Submission of proposals for change to the September 2016 Delay Attribution Guide

PROPOSALS FOR CHANGE TO THE
 DELAY ATTRIBUTION GUIDE
April 2017 Edition
 INDUSTRY FEEDBACK

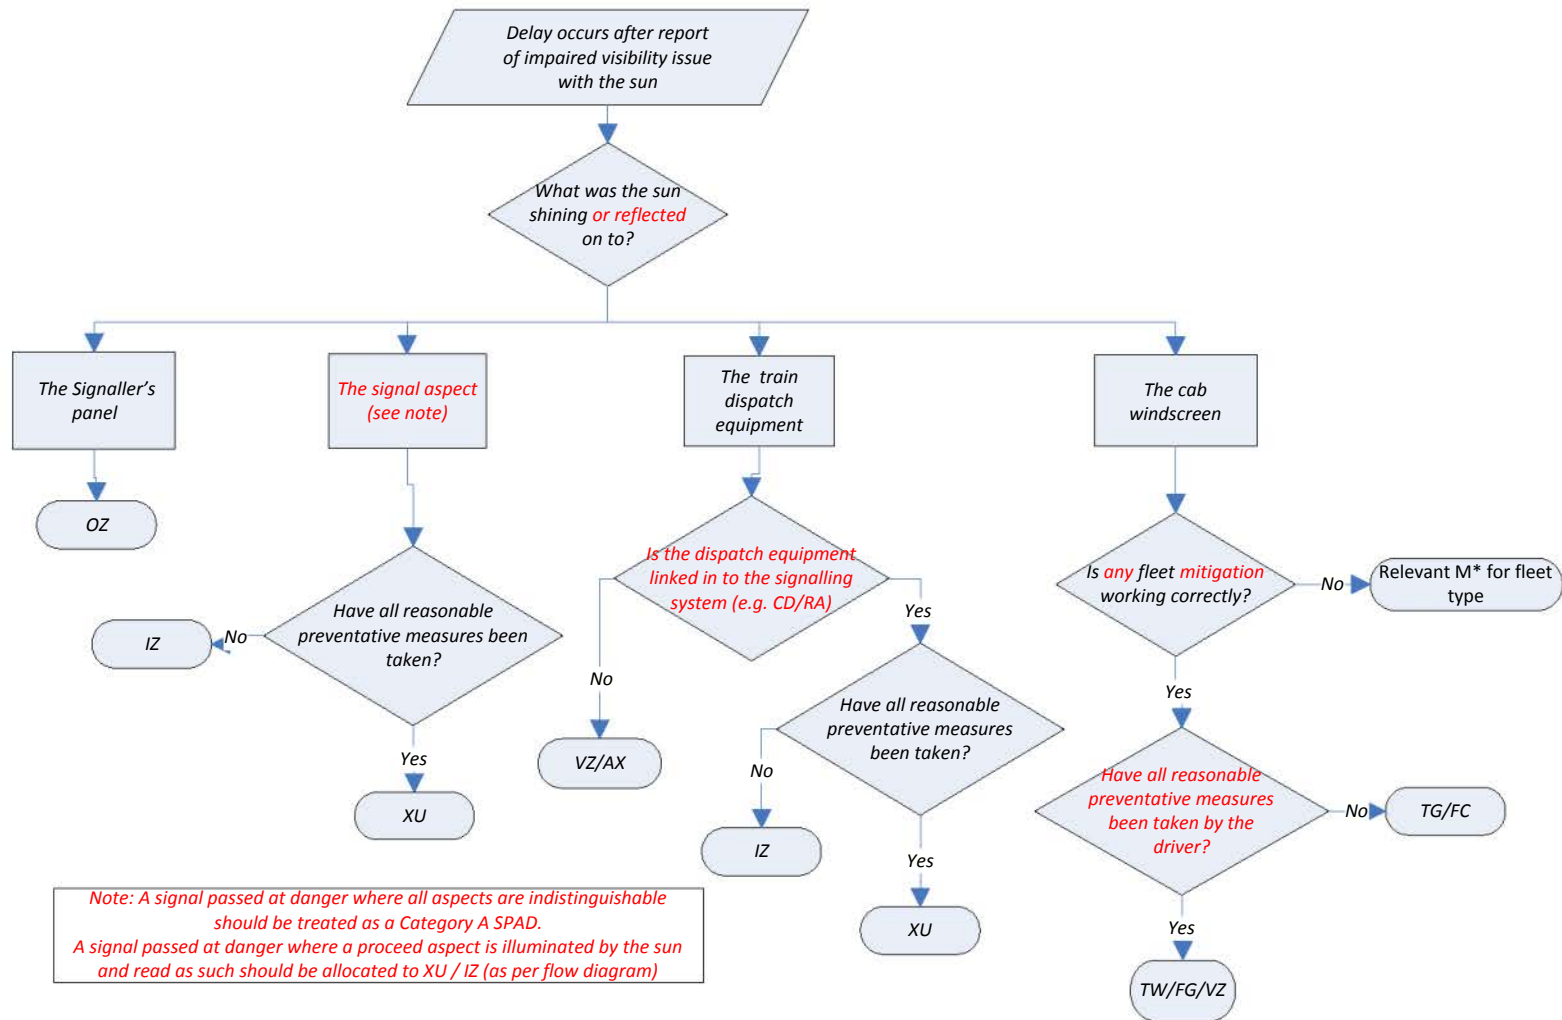
Originators Reference Code / N ^o	DAB P281 - SUN FLOWCHART
Name of the original sponsoring organisation(s)	DAB
Exact details of the change proposed	<p>Amend flowchart in DAG 4.14.5.10 as shown on the attached sheet:-</p> <p>Alterations shown in red.</p>
Reason for the change	<p>In line with the Board's Objectives and following a review of all the flowcharts contained within the DAG a number of proposals have initially been formulated to:-</p> <ul style="list-style-type: none"> • Improve clarity in understanding and application • Correct any errors currently contained (coding, outcomes) <p>Proposals P279 to P283 refer.</p> <p>Note: As only elements of the flowchart have been proposed to be amended, any Consultation feedback should be limited to comments on those proposed changes.</p> <p>Comments on aspects not proposed to be changed would constitute a separate proposal for change.</p> <p>However, feedback is welcome for further reviews in this area.</p>

DAB/P281 Response	Comments
DAMG - on behalf of the identified companies in the response matrix	<p>Accepts this proposal as submitted but:-</p> <p>The guidance should be updated to include level CCTV level crossing cameras.</p> <p>If a camera is “whited out” due to sun light there is no consistent guidance within the flow chart as although part of the signalling system it requires human intervention.</p> <p>Add to “the signal aspect”, “or remote asset monitoring equipment such as CCTV crossings”</p>
VTEC	Accepts this proposal as submitted.
Network Rail	Accepts this proposal as submitted.
DAB DECISION	<p>The Board reviewed and discussed the Industry Consultation feedback at the 17th January 2017 Board meeting.</p> <p>The DAMG respondees’ suggestion for an extra element to be included in the flow diagram, whilst appropriate, would constitute a separate proposal.</p> <p>The proposal was agreed as Consulted with a further proposal to be developed covering the DAMG suggestion.</p>

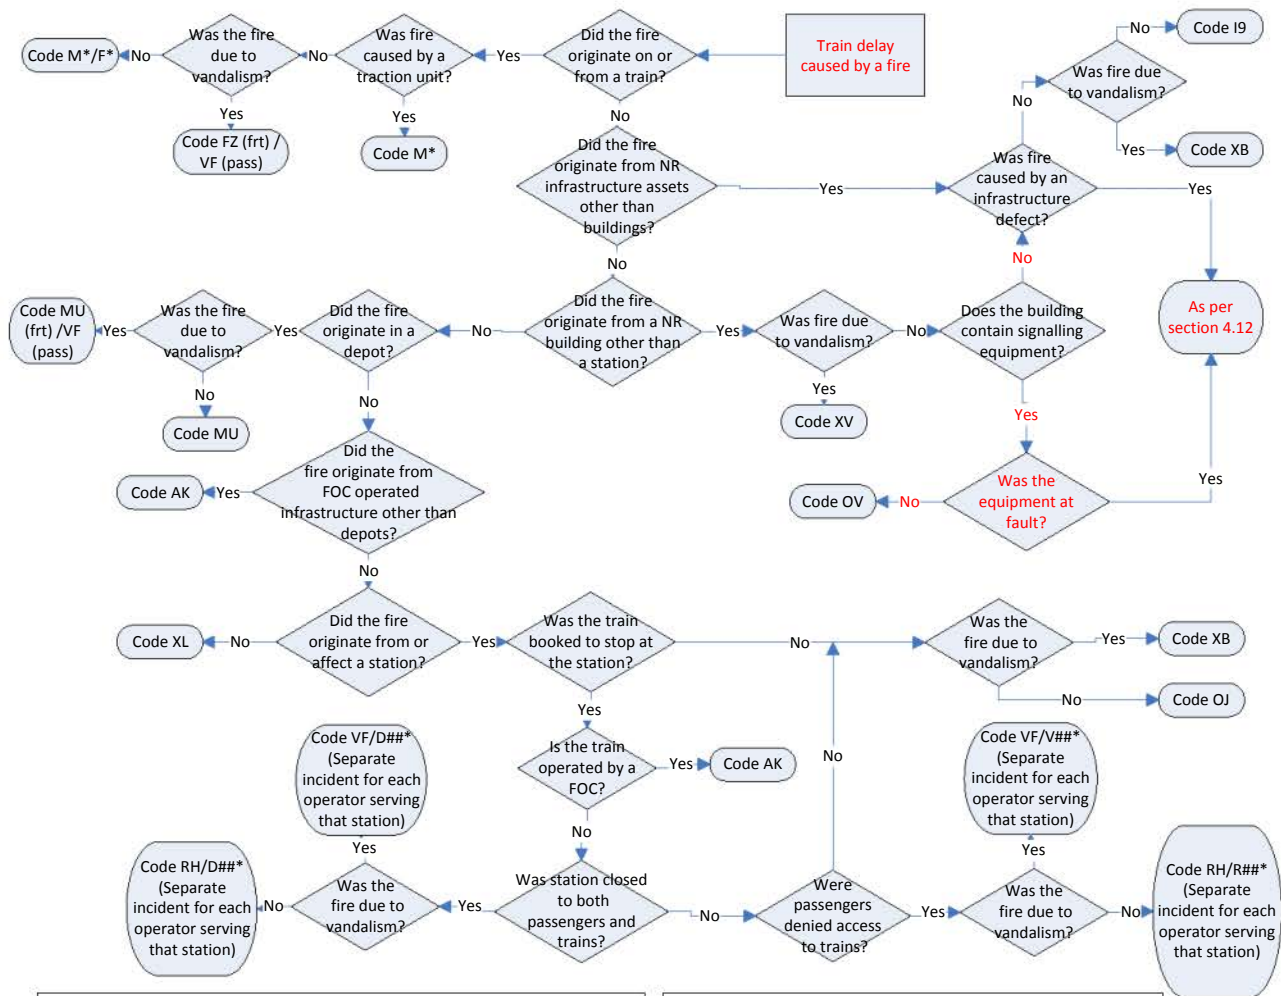
Originators Reference Code / N ^o	DAB P283 - FIRES FLOWCHART
Name of the original sponsoring organisation(s)	DAB
Exact details of the change proposed	Amend flowchart in DAG 4.14.8.8 as shown on the attached :- Amendments shown in red
Reason for the change	<p>In line with the Board's Objectives and following a review of all the flowcharts contained within the DAG a number of proposals have initially been formulated to:-</p> <ul style="list-style-type: none"> • Improve clarity in understanding and application • Correct any errors currently contained (coding, outcomes) <p>Proposals P279 to P283 refer.</p> <p>Note: As only elements of the flowchart have been proposed to be amended, any Consultation feedback should be limited to comments on those proposed changes.</p> <p>Comments on aspects not proposed to be changed would constitute a separate proposal for change.</p> <p>However, feedback is welcome for further reviews in this area.</p>

DAB/P283 Response	Comments
DAMG - on behalf of the identified companies in the response matrix	Accepts this proposal as submitted.
VTEC	Accepts this proposal as submitted.
Network Rail	Accepts this proposal as submitted.
DAB DECISION	The Board reviewed and discussed the Industry Consultation feedback at the 17 th January 2017 Board meeting. The Proposal was agreed by the Board as Consulted.
